Nomad

SERVICE BULLETIN

SUBJECT: RELOCATION OF THE OUTSIDE AIR TEMPERATURE GAUGE.

S/B No. N22-31-1
Page 3 of 6

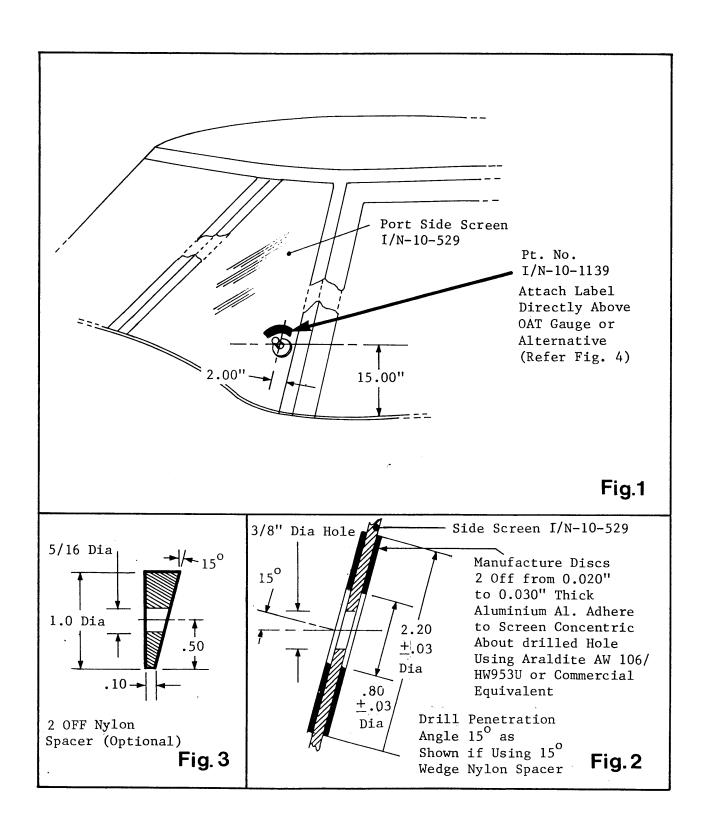
- (3.1) Drill 3/8" dia. hole in the port side screen P/No. 1/N-10-529 using a standard twist drill of 60° to 140° included tip angle, 12° 15° cutting edge clearance angle and zero rake angle and holding drill at right-angles to screen (See Note). Use slow speed and avoid overheating drill and perspex. Refer to Fig. 1 for correct location.

- NOTE: If using optional 2 off 15° angle wedges (Reference Fig. 3) during assy, then penetration of drill into perspex is to be at 15° angle as shown in Fig. 2.

- (3.2) Manufacture 2 off reinforcing aluminium discs as shown in Fig. 2. Pre-form to contour of screen and adhere concentric with hole drilled in 3.1 above using araldite AW106/HW9530 or commercial equivalent.

Fig.4

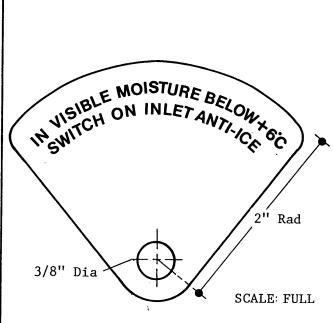
Metal Tag Alternative to Label I/N-10-1139.

Manufacture from Aluminium 0.016" Thick. And Mark By Letraset or Signwriting on White Painted Finish As Shown.

Attach to Inside Screen with Air Temp Gauge Mounting Spindle.
